# Access Compliance Report

## Public Rights-of-Way

Intersection ID: 24685	Main Street: CARDAMON_CT	Cross Street: WILD_HEATHER_CT	Location: S
ADA ID: 7B8F88A03895	Ramp Type: PerpDiag	Initial Pass/Fail: Fail	Overall Compliance: No
Severity Score: 22.5			
Codes/Mitigation Info/Possible Solution		Field Measurements/Component Compliance

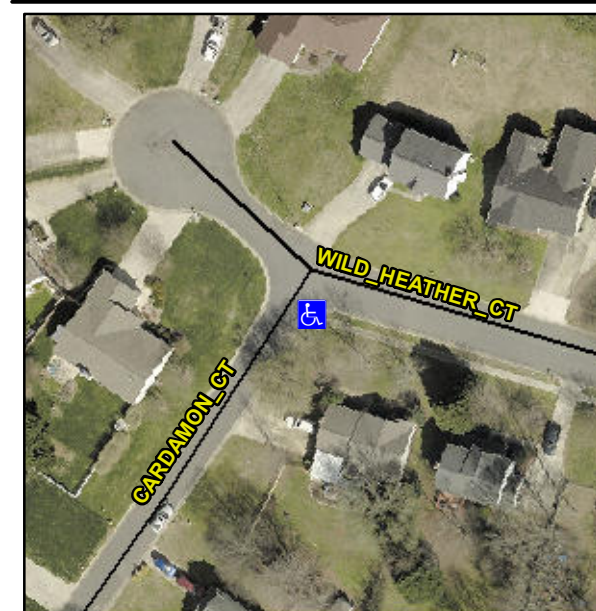
**R304.5.1, R304.2.2, R304.5.3**

Compliance	Description	Data	Compliance	Description	Data
N/A	Ramp Length (in)	93.0	No	Ramp Slope (%)	9.0
No	Ramp Width (in)	44.0	No	Ramp XSlope (%)	4.6
N/A	Flare Type LT	N/A	N/A	Flare Type RT	N/A
N/A	Flare Slope LT (%)	N/A	N/A	Flare Slope RT (%)	N/A
N/A	Flare Traversable LT?	N/A	N/A	Flare Traversable RT?	N/A
N/A	Landing Length (in)	N/A	N/A	DWS Provided?	N/A
N/A	Landing Width (in)	N/A	N/A	DWS Contrast?	N/A
N/A	Landing Slope (%)	N/A	N/A	DWS Length (in)	N/A
N/A	Landing X Slope (%)	N/A	N/A	DWS Full Width?	N/A
N/A	Landing Curb? (Y/N)	N/A	N/A	DWS Offset (in)	N/A
N/A	Shared Landing?	N/A			
N/A	Gutter Ponding?	N/A	N/A	Gutter Slope (%)	N/A
N/A	Gutter Lip Ht (in)	N/A	N/A	Gutter X Slope (%)	N/A
N/A	Painted X Walk1?	No	N/A	Painted X Walk2?	No
	X Walk 1 Direction	To NE		X Walk 2 Direction	To NW
N/A	X Walk 1 Width (in)	N/A	N/A	X Walk 2 Width (in)	N/A
	X Walk 1 Slope (%)	4.5		X Walk 2 Slope (%)	0.1
	X Walk 1 X Slope (%)	1.0		X Walk 2 X Slope (%)	2.8

**Remove & Replace Curb Ramp With Two New Directional Ramps or Equivalent.**
